**BEFORE THE PUBLIC UTILITY COMMISSION  
OF OREGON  
LC 52**

In the Matter of	)	
	)	SIERRA CLUB’S PRELIMINARY
PACIFICORP	)	COMMENTS
	)	
2011 Integrated Resource Plan	)	
_____	)

**I. Introduction and Recommendations**

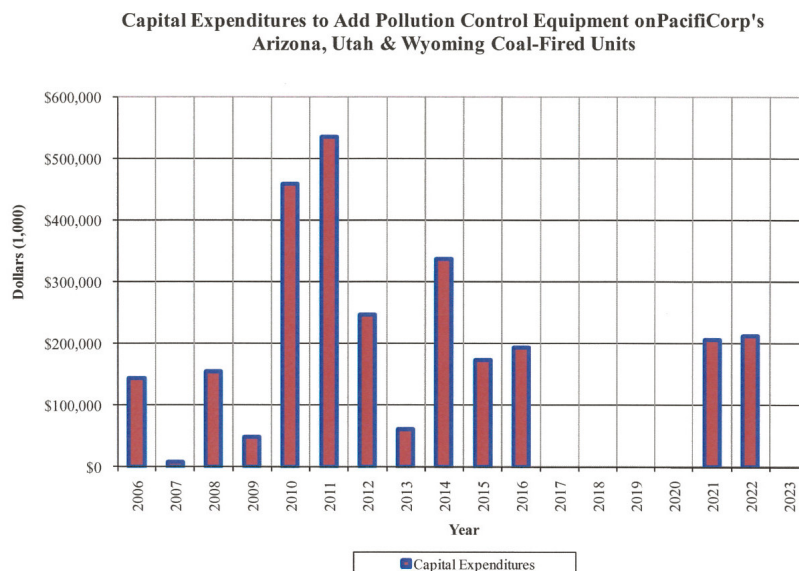
The largest environmental deadlines looming are the final EPA approved regional haze rules and requirement to meet toxic air emissions limits. Indeed, the company's emissions planning document [Exhibit 2] suggests that PacifiCorp will make most of its environmental investments prior to these deadlines (see figure below).

The 20-yr capacity additions, as shown in the “Portfolio Development Results” presentation from January 28, 2011, are shown in the figure below.

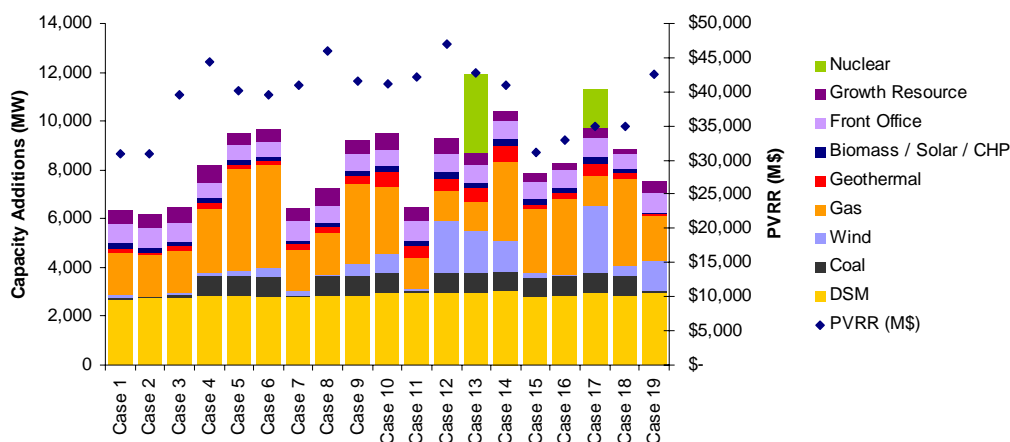
Indeed, the portfolios presented to stakeholders show extremely consistent results: a fixed amount of DSM made available in each core scenario (over 20 years, ~1,300 - ~1,500 MW in the

East and ~1,250 MW in the West),<sup>3</sup> little geothermal in near-term years, gas to meet capacity requirements in the near term, and variable amounts of wind in the longer-term. Most of the coal and nuclear additions only occur in the model in year 2030, neither substantively impacting model results nor the net present value.<sup>4</sup> The results are convoluted by the ambiguous “front office transactions” and “growth resources”, which have undefined cost, energy implications, or emissions.

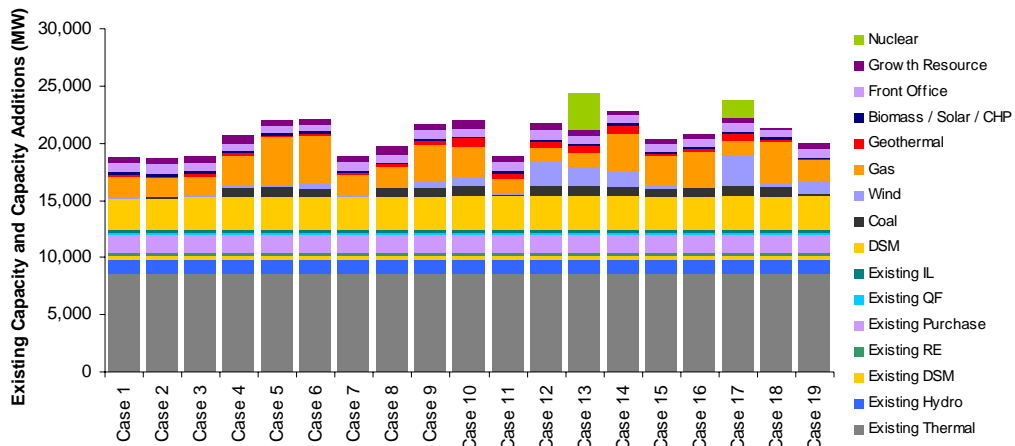
What these development scenarios do *not* show are the unchanging portfolios underlying the new capacity additions, now added into in the figure below.

By having left these resources intact in the only considered scenario runs, and not evaluating the forward-going costs of operating existing units on an economic basis, the Company needlessly exposes ratepayers to unnecessary financial and regulatory risk, such as required improved environmental controls on existing coal plants, a price on greenhouse gas emissions, and rising coal prices, all of which expose ratepayers in the existing fleet.
